Board of Adjustment **Notification Plan for** **Case No A-19-10300050**

REPAIR 95 FT PYLON

Design #	
0610405AR3	
Sheet	3 of 3
Location	
#363	
Address	
4635 RITTIMAN RD SAN ANTONIO, TX	
Acct. Rep.	DEBBIE MOLTZ
Coordinator	STEPHANIE MOORE
Designer	IH
Date	6/11/15
Approval / Date	
Client	
Sales	
Estimating	
Art	
Landlord	
Engineering	
Revision / Date	
R1(06/12/15)UE REMOVED SECONDARY CABINET AND ADDED A "AFTER" PHOTO.	
R2(07/15)IH: ADD REPAIR SCOPE FROM ENGINEERING. ADD 95 FT PYLON WITH REPAIR SCOPE FROM ENGINEERING. SHOWING PEDESTAL. ADD SITE PLAN ON PAGE 1 WITH PYLON LOCATIONS.	
R3(2-26-16)IH: REDUCE OAH

BOA-19-10300050
Subject Property – 4635 Rittiman Road

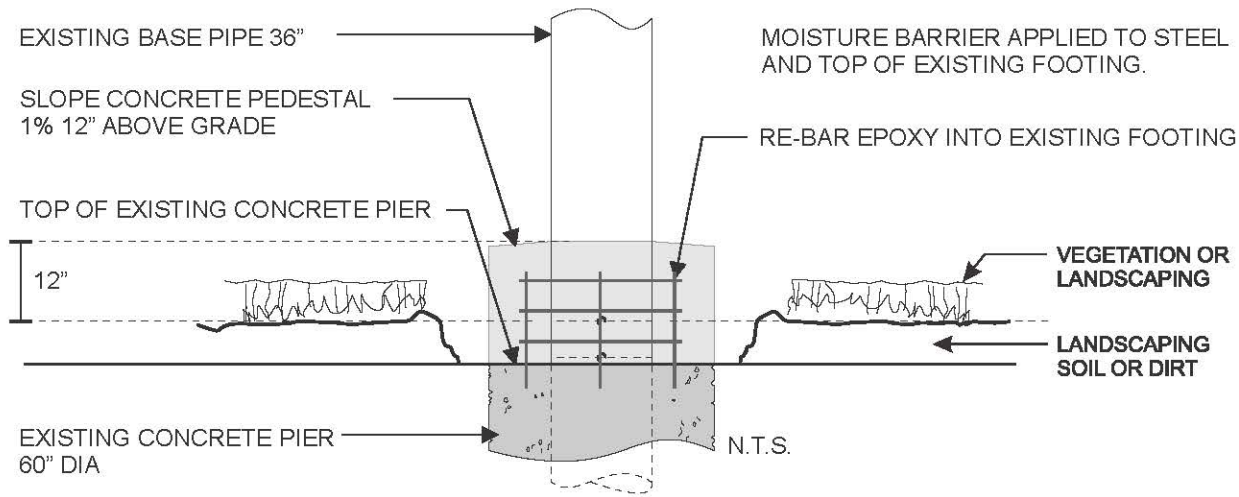
REDUCE OVER ALL HEIGHT

REDUCE O.A.H.
KEEP PORTION OF 20" STEEL TO SLEEVE INTO 30" WITH NEW STOP PLATE AND 2 NEW RING PLATES.

- 1 - ADD CONCRETE PEDESTAL WITH RE-BARS AND EXTEND TO 12 INCH ABOVE GRADE. DOWEL RE-BARS INTO EXISTING FOOTING WITH EPOXY. COMPLETELY REMOVE RUST AND EXISTING PAINT FROM STEEL, PRIME AND PAINT PRIOR TO ADDING CONCRETE.

- 2 2ND AND 3RD TRANSITIONS FROM GRADE: ADD STEEL GUSSETS AS SHOWN ON DRAWING TO REINFORCE CAP PLATE (EXTENSION DEFICIENCY)
- 3 ALL TRANSITIONS: CHECK ALL RING PLATES FOR PLUG WELDS AND ADD IF MISSING. ADD MINIMUM FOUR (4) ONE (1) INCH LONG WELDS @ EACH PLATE. ALSO COMPLETELY FILL EXISTING HOLES AT RING PLATES WITH WELD MATERIAL.
- 4 ALL TRANSITIONS: ADD ADDITIONAL WELD PASS BETWEEN CAP PLATE AND BOTTOM STEEL SUPPORT.
- 5 SCRAPE / GRIND REMOVE OLD EXCESS PAINT AND RUST ON MAIN SUPPORT PIPE AT ALL TRANSITIONS FROM 1 FOOT ABOVE CAP PLATE TO 1 FOOT BELOW LOWEST RING PLATE. PRIME AND RE-PAINT.
